## Clause 4.6 Variation to the building height development standard

The Sydney Region Growth Centres SEPP (2006) identifies the maximum building height of 12 m for the site. The DA seeks approval for a multi dwelling housing development where part of the roof area of Blocks A & E is above the maximum height plane. The applicant's formal request is at the end of this attachment.

Figure 3 – 3D height plane blanket showing breaches  
Source: WMK

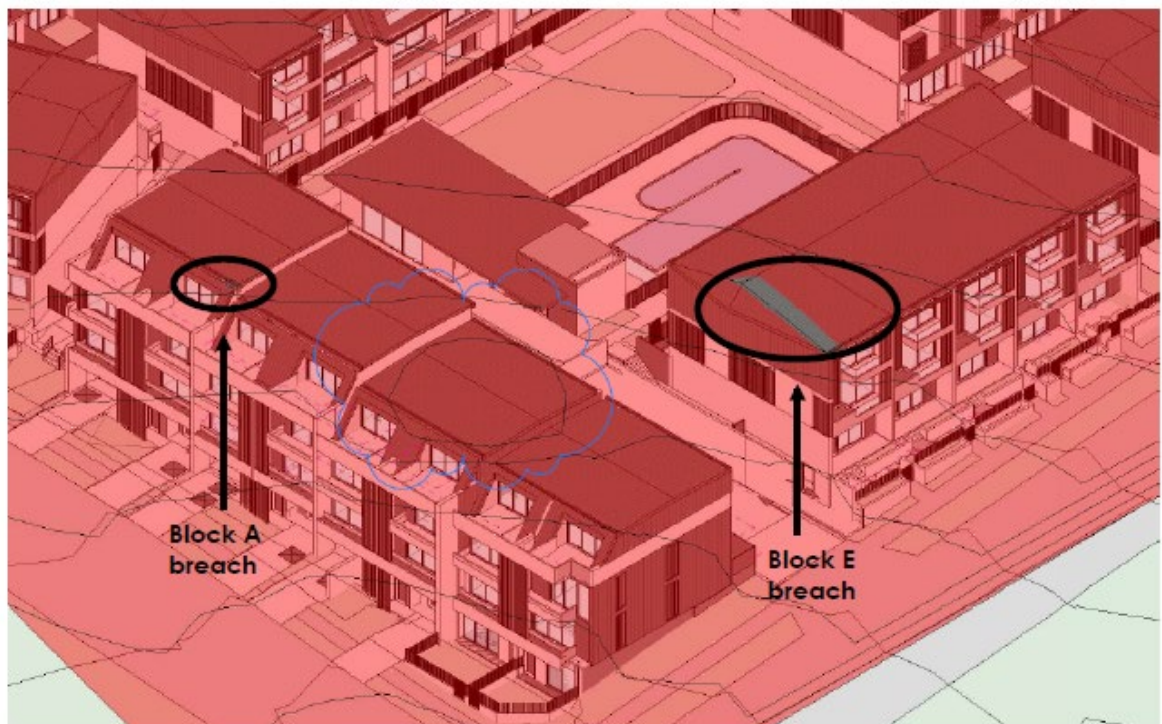
The proposed development seeks to vary Clause 4.3 of State Environmental Planning Policy (Sydney Region Growth Centres) 2006 which prescribes a maximum height of 12 m for the subject site. Block A has a maximum height of 12.170 m and Block E 12.250 m, representing a departure of 1.4% to 2.3% from the maximum height standard.

The following figures identify the parts of the building envelope that exceed the 12 m height limit.

- On average, the development would be below the height limit. Only two discrete areas of the site at Blocks A and E breach the limit. The areas of the breach are not conspicuous extensions but rather integrated components of the overall building form.

- The sloping nature of the site makes it difficult to achieve strict compliance. One potential solution is to sink the buildings further into the ground. However, this strategy would adversely affect access to the dwellings, in particular sinking Block A would require additional steps down from the internal footpath to the front door and result in an undesirable sunken dwelling entry and private open space. Similarly, sinking Block E would require stepping down from the natural internal footpath and result in an undesirable sunken private open space.

- The non-complying part of Block E is limited to the sloping roof and therefore strict compliance could potentially be achieved by providing a flatter roof. However, it is considered this would result in an inferior architectural outcome, as the sloping nature of the roof provides an appropriate architectural termination of the building.
- The non-complying part of Block A facilitates the provision of high amenity private open space integrated into the roof design. Achieving strict compliance by truncating the height of the building would require removing the private open space, resulting in a loss of amenity. Additionally removing a storey at this portion of the building would disrupt the rhythm and proportions of the building and result in an abnormal building form inconsistent with the other building on the site.

Based on the above assessment, the Clause 4.6 variation request is considered reasonable, well founded and meets the objectives of the R3 Medium Density Residential zone and the height of building development standard in Clause 4.3 of State Environmental Planning Policy (Sydney Region Growth Centres) 2006. Therefore, it is recommended that the Clause 4.6 variation is supported for the following reasons:

- a. Adherence to the height standard is unnecessary in this instance as no adverse impacts will result from the variation to the Height of Building control.
- b. The roof structures that exceed the height limit do not result in excessive bulk and scale.
- c. The additional height does not result in any additional floor area.
